Planning Commission

A request for site plan approval for improvements to the property known as Central Lofts, 500 Erie Street.

**Re: Site Plan Review, Central Lofts Condominiums
500 Erie Street, South Haven, MI**

RE: Final Site Plan Review
Central Lofts Phase II
500 Erie Street

R.O.W. IMPROVEMENT PLAN

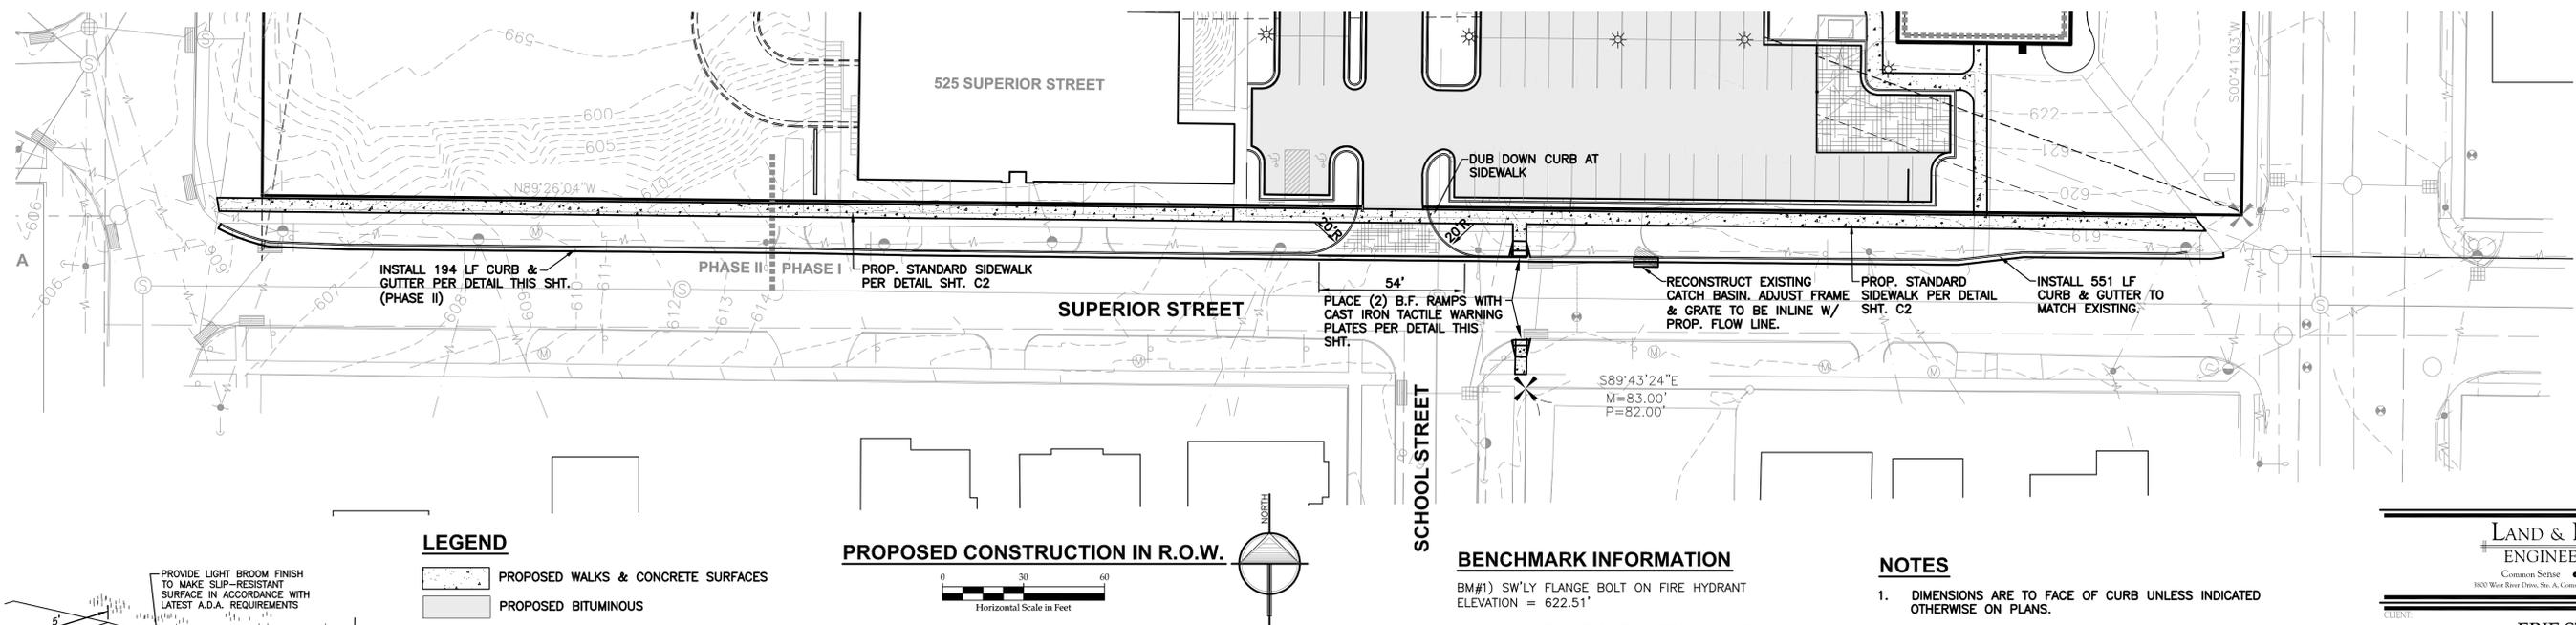
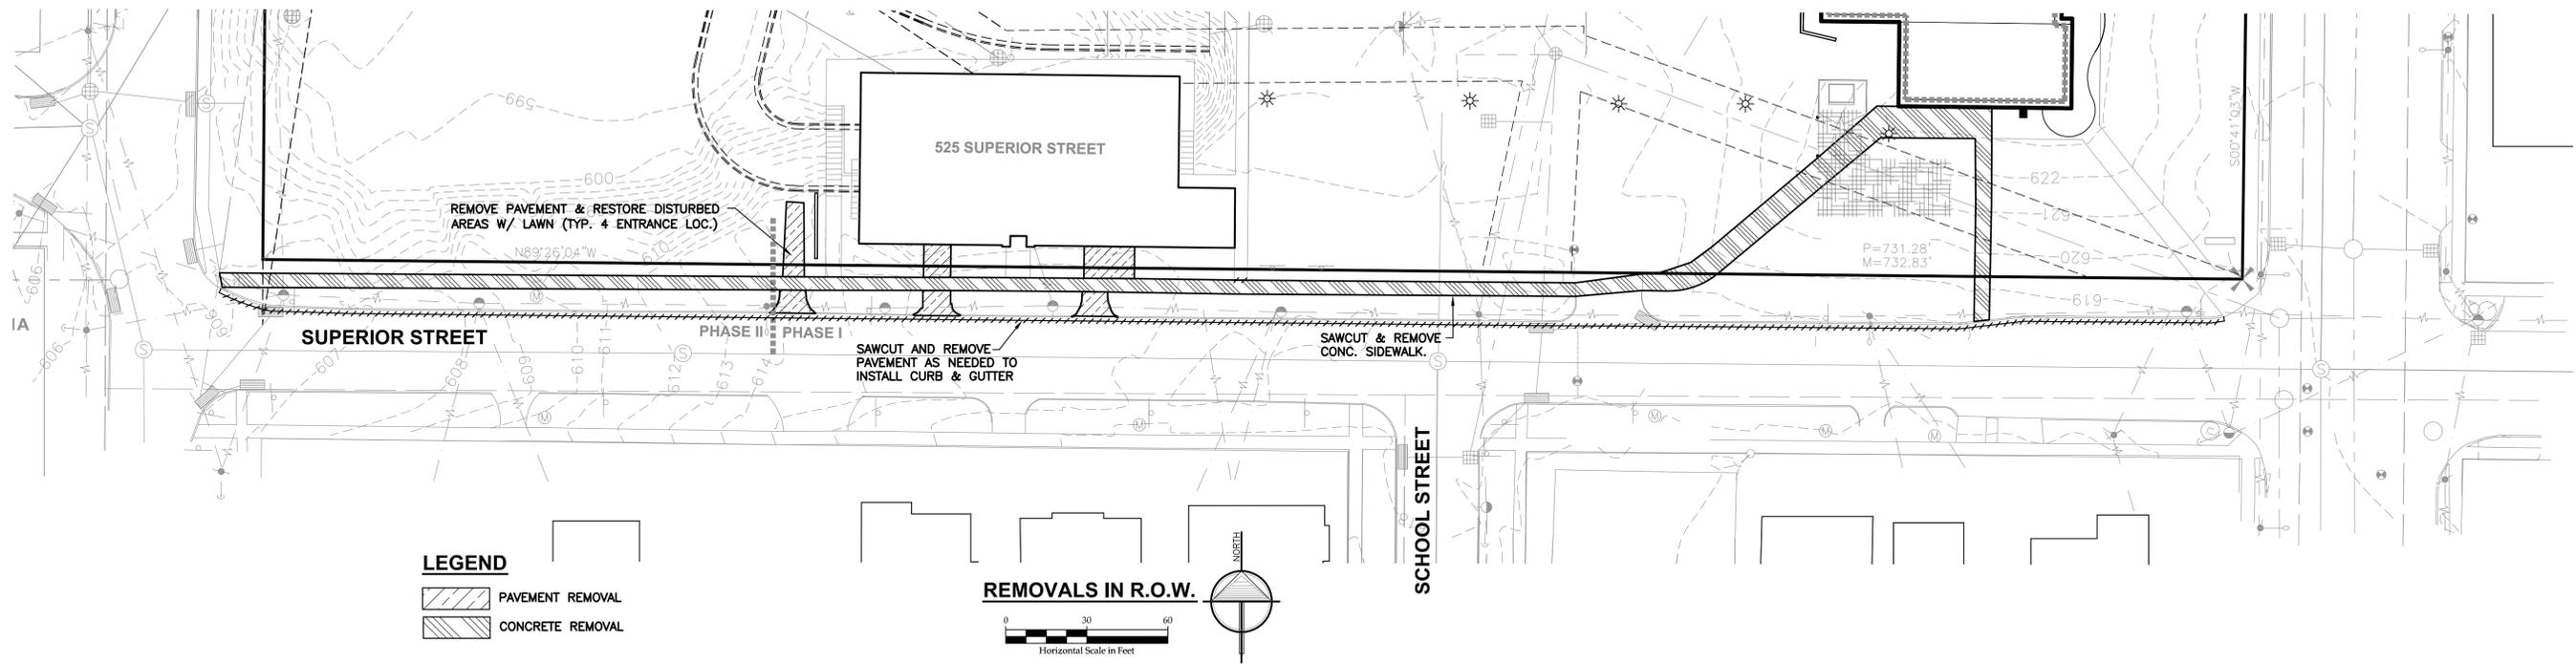
There are four existing driveways providing site access along Superior Street. All existing driveways must be removed and closed during Phase I of street work. The new sidewalk shall be continuous across the new driveway and match the concrete pavement thickness of the driveway. The curb and gutter shall be terminated on each side of the sidewalk with a standard dub down. Barrier free ramps at the driveway are not required.

A new barrier free ramp shall be installed to align with the west sidewalk on School Street. The tactile warning plates shall be cast iron. Plastic or imprinted concrete tactile warnings are not permitted. The location of the proposed driveway is not acceptable because it interferes with proper construction of the new barrier free ramp. The driveway location needs to be moved easterly to avoid conflicting with the barrier free ramp location.

The proposed driveway construction shall comply with Section 74-132(a) of the City of South Haven Code of Ordinances which states: The design, location, construction and operation of driveways and related construction shall meet the requirements of the state department (of) highways rules pertaining to driveways. The current rules promulgated by the Michigan Department of Transportation are the Administrative Rules regulating Driveways, Banners and Parades, effective on November 30, 1998. Design features are outlined in R247.233 and illustrated in Figure 1. R247.251 requires commercial driveway surfacing to include curb and gutter. The driveways shall be constructed with MDOT F-4 concrete curb and gutter radii and with MDOT, Detail M concrete gutter pan across the openings. Standard plans for these features may be found on the MDOT web site. The design feature dimensions shall be in accordance with R247.241, Table 2, as a minimum. The entering radius must be increased to 20 feet, minimum. The driveway width at the sidewalk must be 25 feet for two way access per Section 1716.1.i of the Zoning Ordinance.

Paragraph 1: Phase I of the Superior Street Right-of-Way improvements has been moved west to include the removal and closure of all four (4) existing driveways. See sheet C5.

The plans have been revised to show the sidewalk continuing across the new driveway and matching the pavement thickness. The curb and gutter terminates on either side of the sidewalk with standard dub down and the barrier free ramps at the driveway have been removed.

Paragraph 2: Rather than moving the entrance drive we have added two new barrier free ramps on the east side of School Street that line up on the North and South sides of Superior Street (per discussion with Larry Halberstadt, PE on June 7, 2013). See sheet C5.

PHOTOMETRIC LIGHTING PLAN

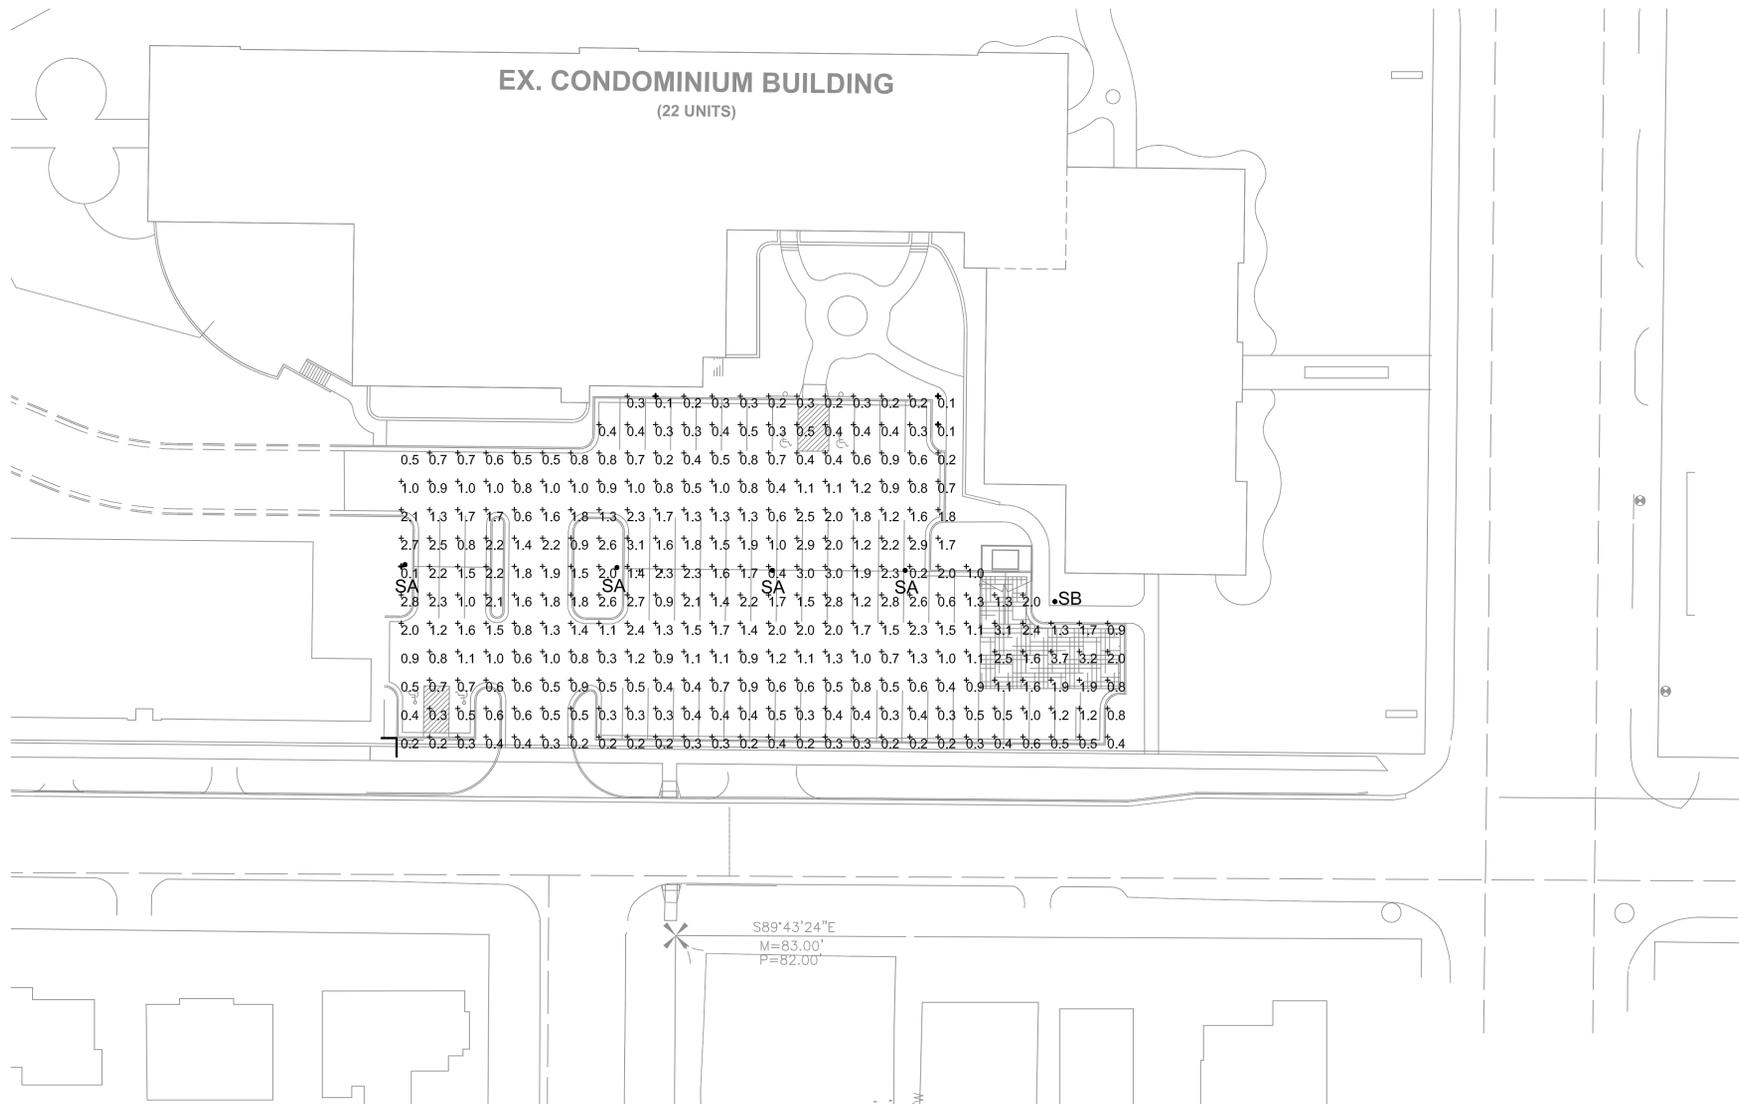
1. We will need a photometric detail for the exterior lighting as well as a photograph of the fixtures proposed. If the bulb extends below the upper cap, the fixtures will likely not be approved.
2. The trash receptacle needs to be screened. Screening detail must be shown.
3. A plant list needs to be provided that gives common plant names as well as abbreviated scientific names (eg., car. bet.)
4. The proposed driveway appears to dead end at a vacant building that is not part of this submittal (noted as vacant building w/future development). If the building is to be used in any way, it needs to be part of this submittal. That is, if you plan on using the building for parking, we need details of the parking area proposed. If you are not including the building in this submittal, do not extend the driveway to the building.

1. A photometric plan has been included with this submittal.
2. A detail for the trash receptacle is included.
3. A plant list giving the common plant names has been included with this submittal.
4. The proposed driveway to the lower level of 525 Superior has been shown as a future drive. This will be constructed in a future phase and will be subject to site plan review at that time.
